## Procedural, Safety, and Design-Based Objection to Proposed Four-Storey Development

I write to formally object to planning application 2025/92156 for Plot 27, Lingards Road, on the basis of multiple unresolved safety, accessibility, and design concerns. The proposal introduces vertical intensification and multi-unit occupancy without demonstrating compliance with key regulatory standards, including Approved Documents B, K, and M, BS 9991, and inclusive design principles.

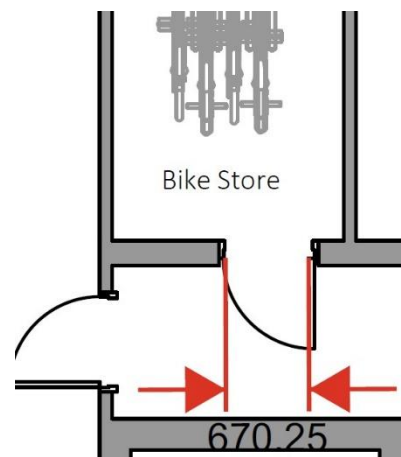
The proposed ground floor includes a communal gym, bike store, protected stair lobby, lift, and a private garage. While these amenities suggest thoughtful provision, the layout raises several procedural and practical issues:

- **Bike Store:**

- The access door measures only **670.25mm**, well below the **900mm minimum** recommended for inclusive access.
- The door is hinged on the obstructive side, requiring awkward manoeuvring and increasing the risk of damage.
- The store accommodates only **4 bicycles** for up to **12 residents**, contradicting sustainable transport principles.
- No internal compartmentalisation or secure locking points are shown, leaving bikes vulnerable to tampering or theft.

- **Lift clearance:**

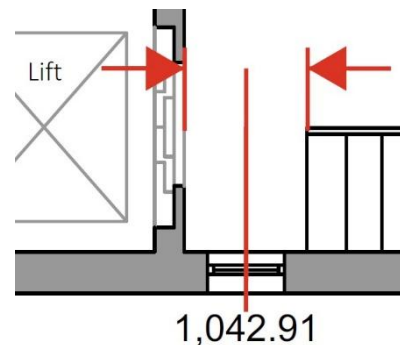
- The lift opens onto a landing with only **1.04m of clearance** measured before a descending stair flight—below the **1.5m minimum turning space** required under Approved Document M.

### Rear Elevation – Proposed Elevation 3

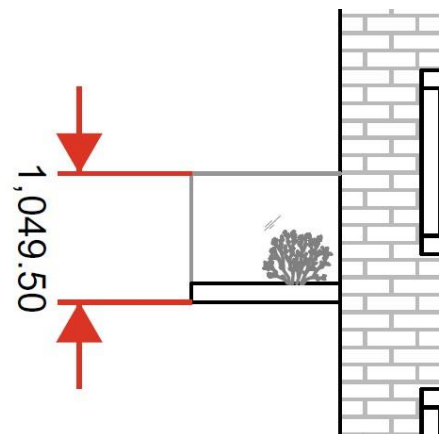
The rear elevation presents a symmetrical layout and active ground-level frontage, but fails to exploit the architectural potential of its stone façade:

- The repetition of identical windows across all storeys and lack of entrance emphasis result in a **flat and generic appearance**.
- The façade lacks vertical articulation and depth, despite the material choice.
- The elevation does not reflect the contextual integration or contextual sensitivity expected of stone-built development in this area.

### External Steps – Non-Compliant Dimensions

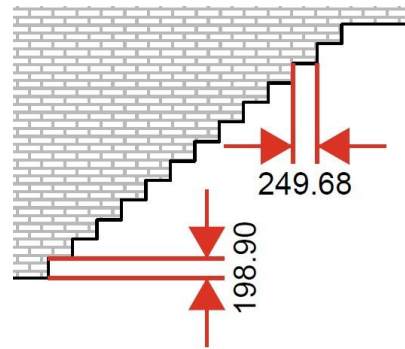
The proposed external steps show a **rise of 198.9mm** and a **going of 249.68mm** as measured—both outside the acceptable range set out in Approved Document K:

- The rise exceeds the **maximum 170mm**, making the steps excessively steep.
- The going falls short of the **minimum 280mm**, reducing tread surface and increasing trip risk.
- This steep pitch is especially hazardous in external conditions and for vulnerable users, rendering the steps non-compliant and unsafe.
